October 30, 2015

RE: Comments of Friends of Stone Lakes National Wildlife Refuge on Draft Bay Delta Conservation Plan/California WaterFix and Associated Partially Recirculated Draft Environmental Impact Report/Supplemental Draft Environmental Impact Statement

EXHIBIT 1

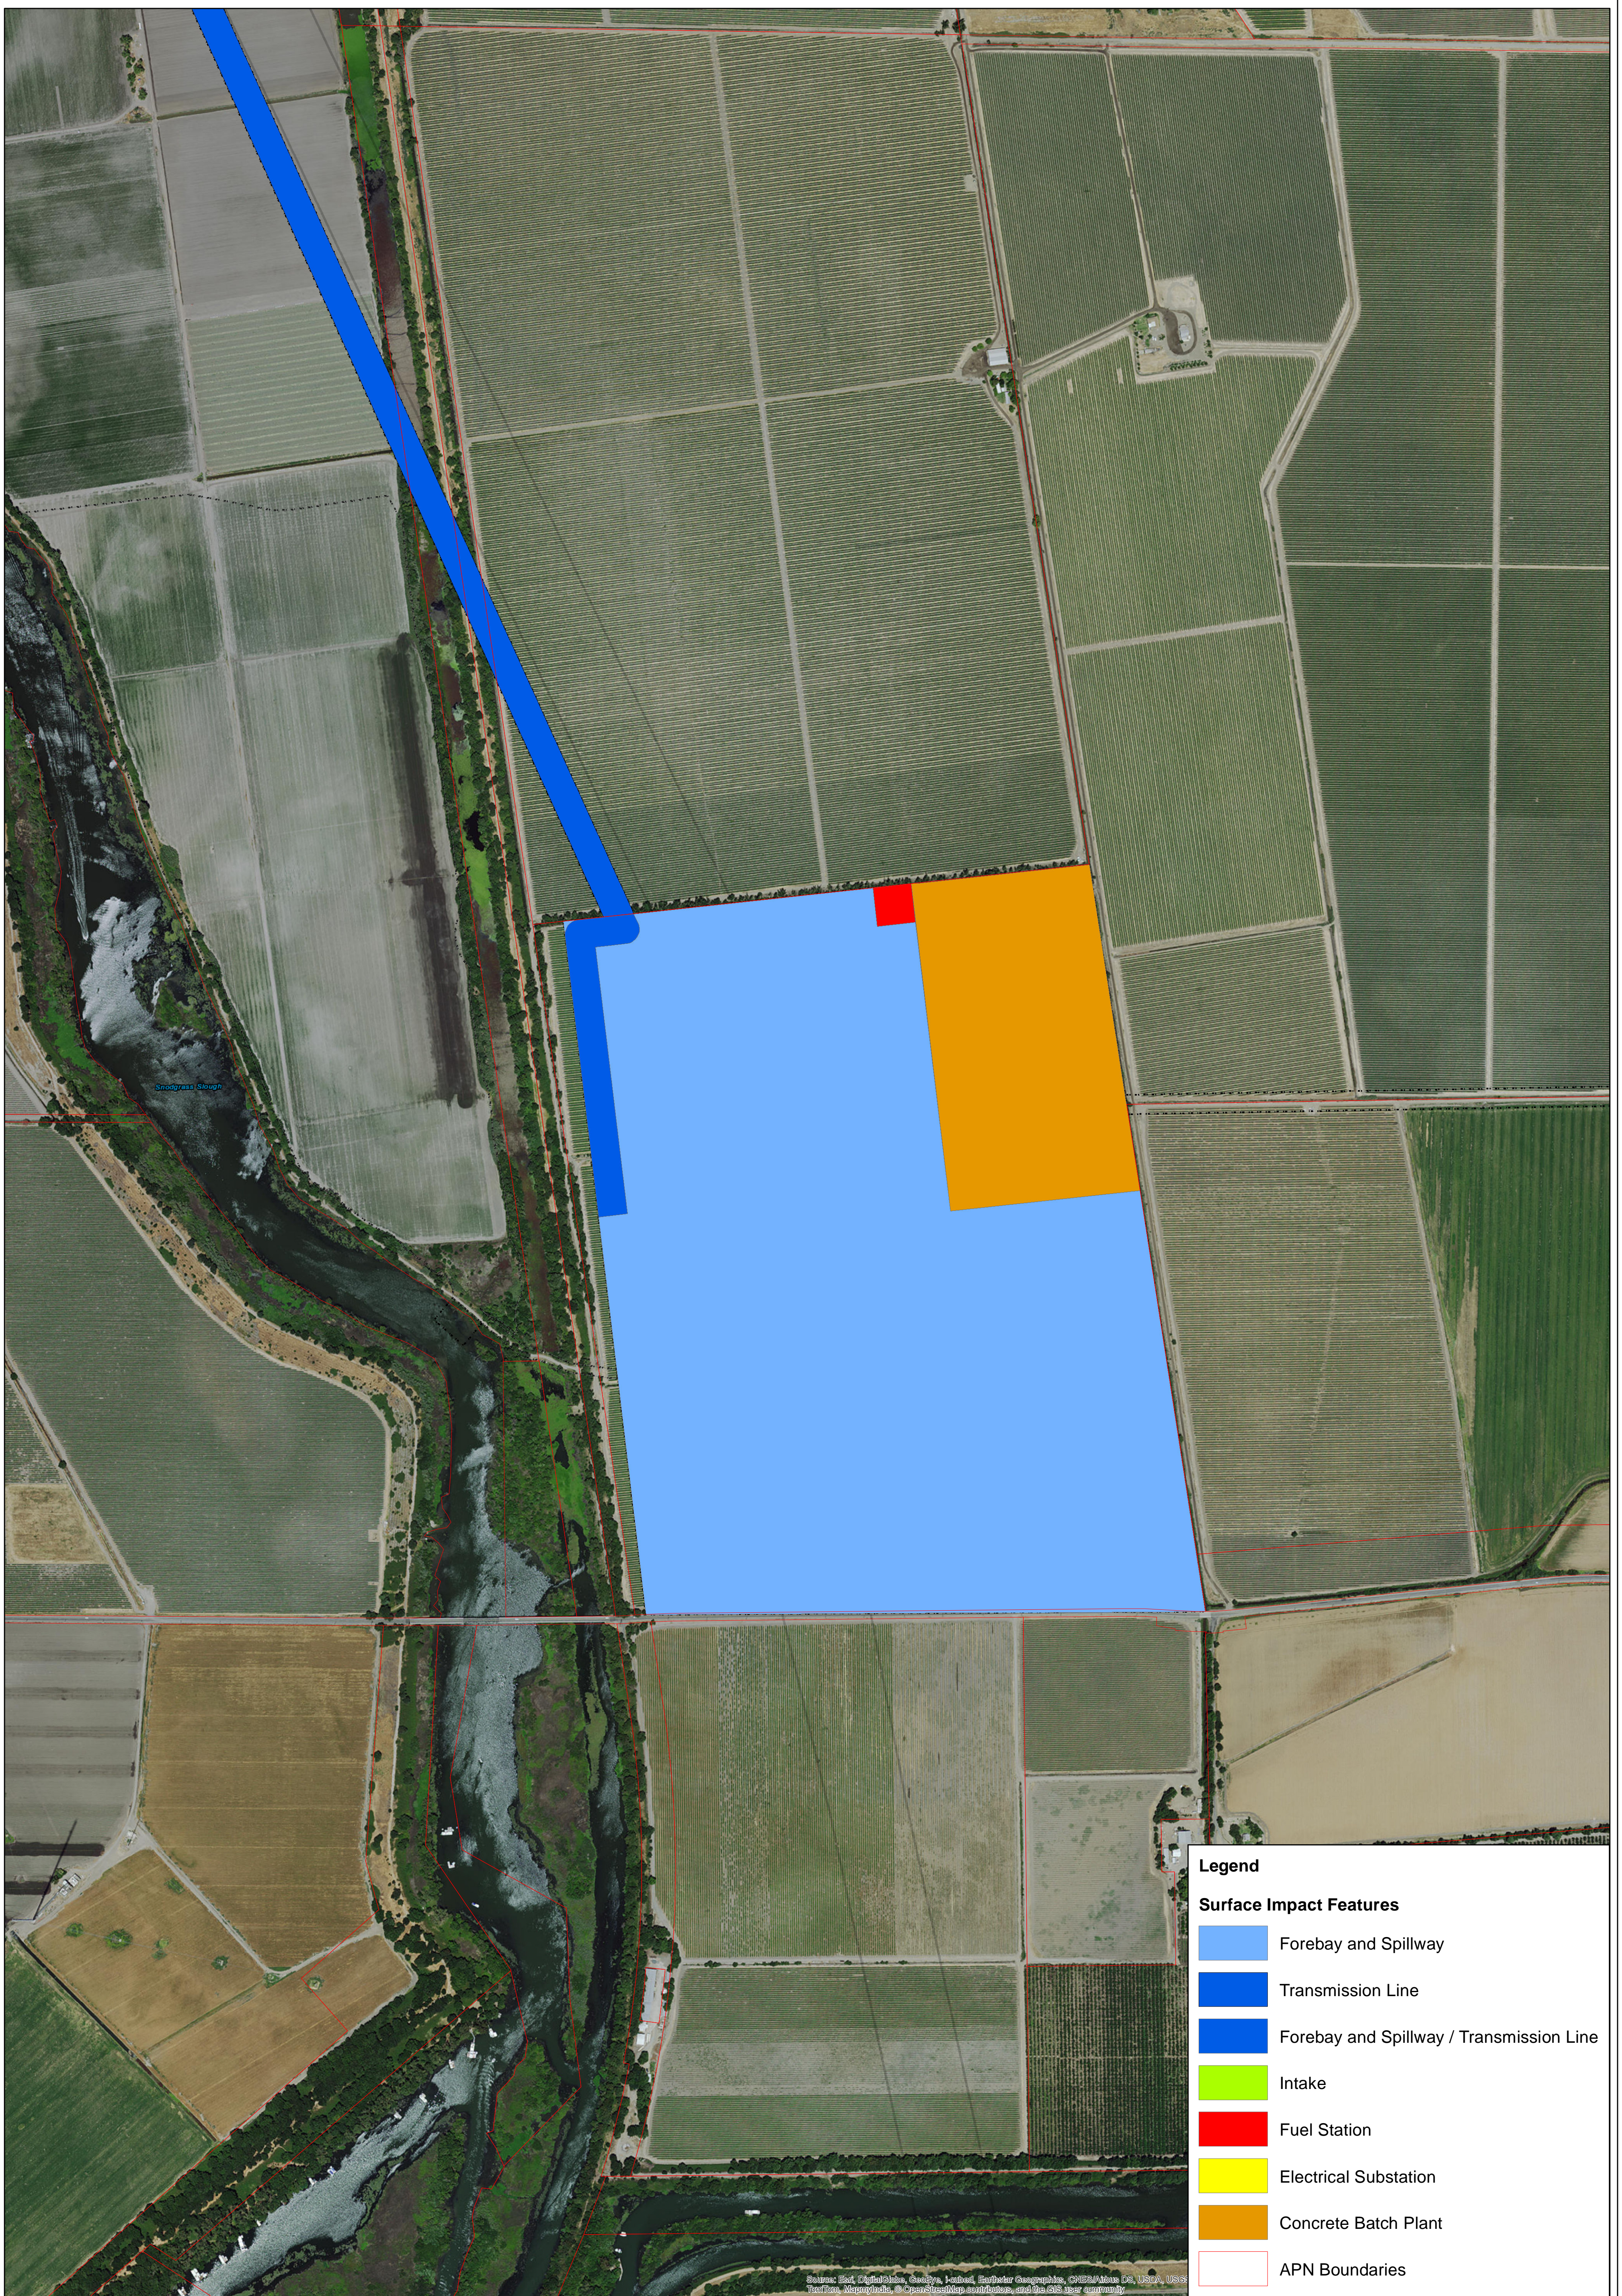
The Refuge is ground zero for this project. (See Exhibits 1 and 2, Surface Impacts Figures.) Stone Lakes NWR is adjacent to all three proposed Tunnel Intakes, and the Intermediate Forebay is located within the Refuge Boundaries. New power lines are proposed to cross the Refuge as well. Geotechnical exploration, construction equipment and associated traffic and noise will interfere with the Refuge for much of the fourteen-year construction period, and then industrial-scale water infrastructure will permanently dominate the landscape and the nearby Sacramento River. A place Congress specifically chose to save changed forever.

Permanent Surface Impacts
 Proposed Forebay Area
 BDCP Fix Alternative 4A
 Figure B

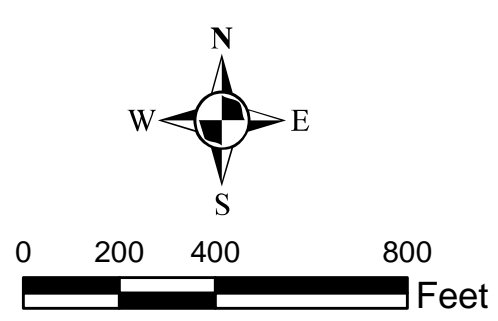
A good example of the inadequacy of the implementation of the ECs is the case of the impacts of the forebay upon the Refuge. FSL believes that the location of the proposed forebay within the Refuge Project Boundary, together with the use of Zacharias Island to the west of the forebay as a tunnel muck storage area, when taken in conjunction with all of the cumulative effects of other aspects of the Project, necessitates the acquisition of all of Zacharias Island for wildlife habitat, and its permanent protection such as by incorporation into the Refuge, in order for there to be any type of a complete or adequate mitigation measure. This issue is discussed in great depth in FSL’s letter of July 25, 2014, and nothing in the RDEIR/S has changed any of FSL’s concerns in this regard.

Bird Diverters on Staten and Woodbridge Island Jan. 2015

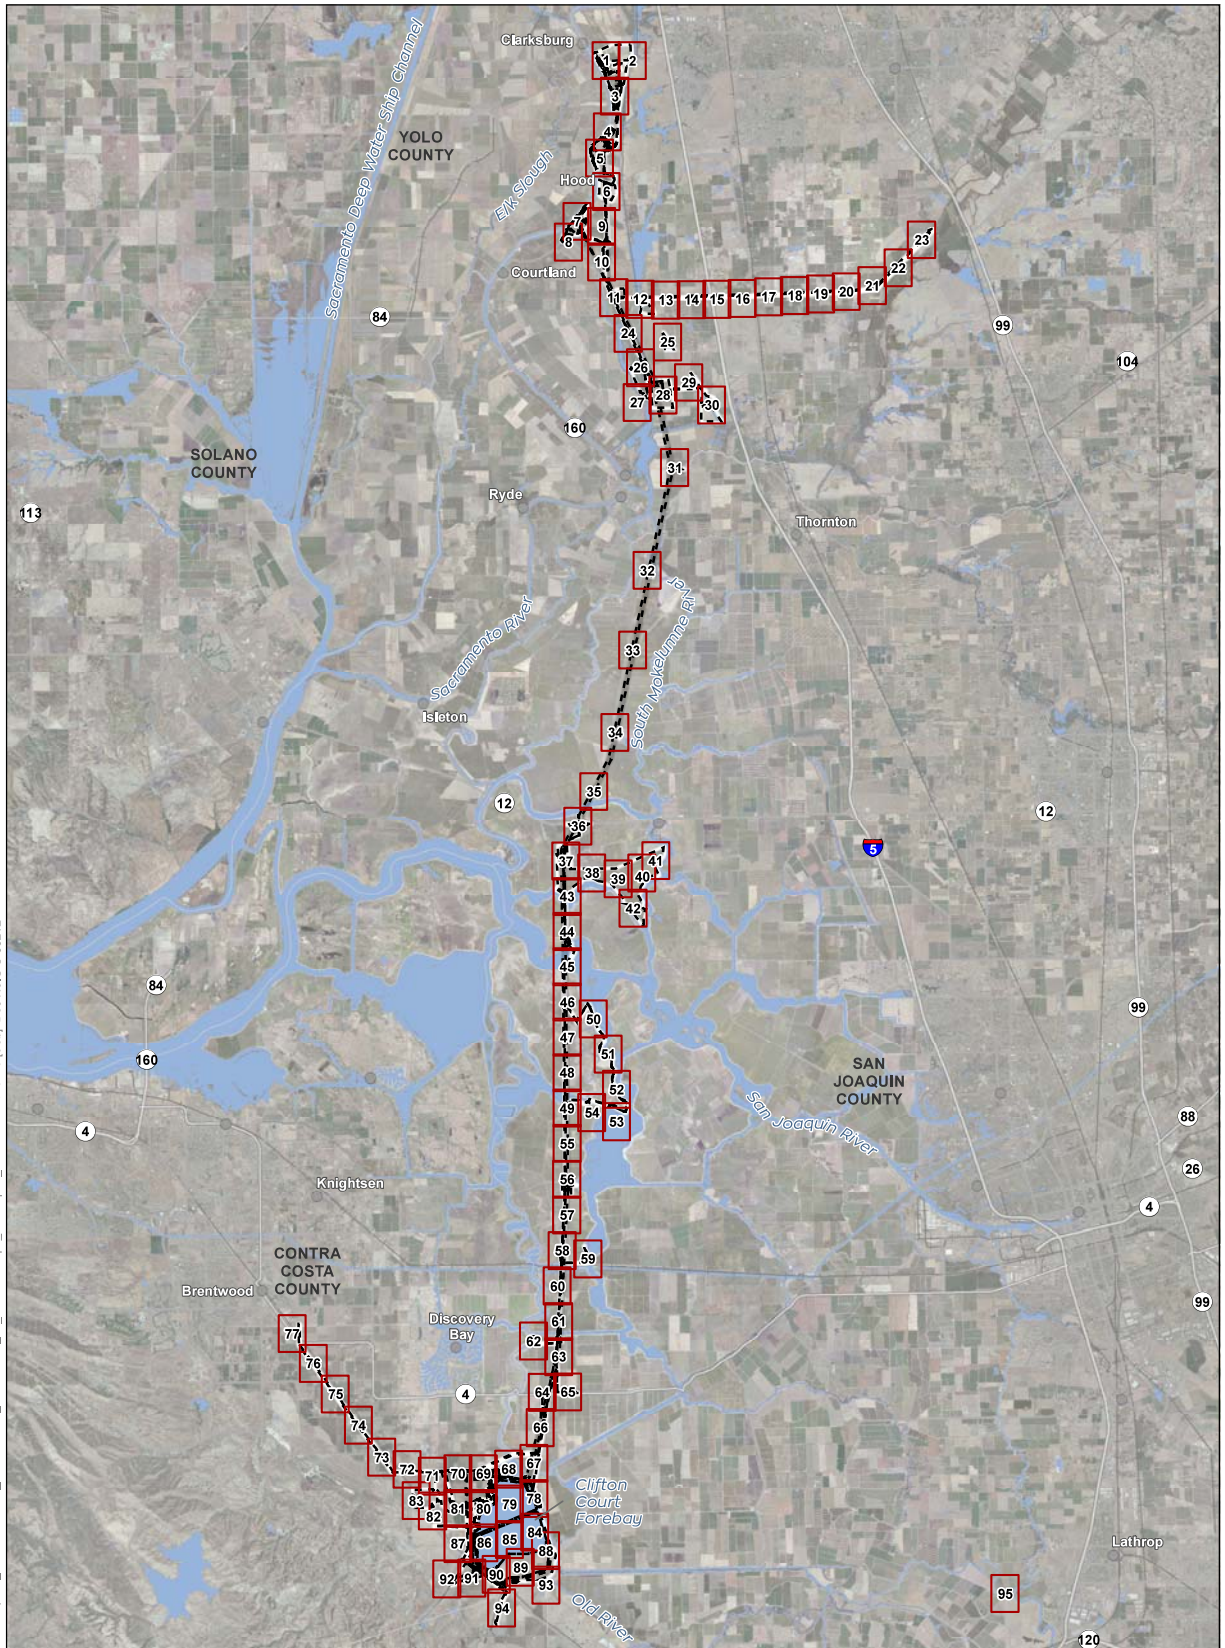
As recognized previously in the DEIR/S and more recently by the Delta Independent Science Board, construction of new transmission lines to power construction and operation of the project will lead to bird strike deaths. (September 30, 2015, DISB Letter, pp. 3, 17.) The Lead Agencies previously estimated that there would be 138 deaths per year, which is estimated to be reduced to 48 deaths per year if the power lines are marked. (See 2013 Draft BDCP, Appendix 5.J.C, p. 18 and Table 2, attached as Exhibit 3.)³ The reduction in bird strikes was attributed to according to a Colorado study indicating that a 66% reduction in bird strikes could be attained through marking. (2013 Draft BDCP, Appendix 5.J.C, p. 18.) This lack of proper maintenance of bird diverters also diminishes their effectiveness. (See Exhibit 4, Broken Bird Diverters.)
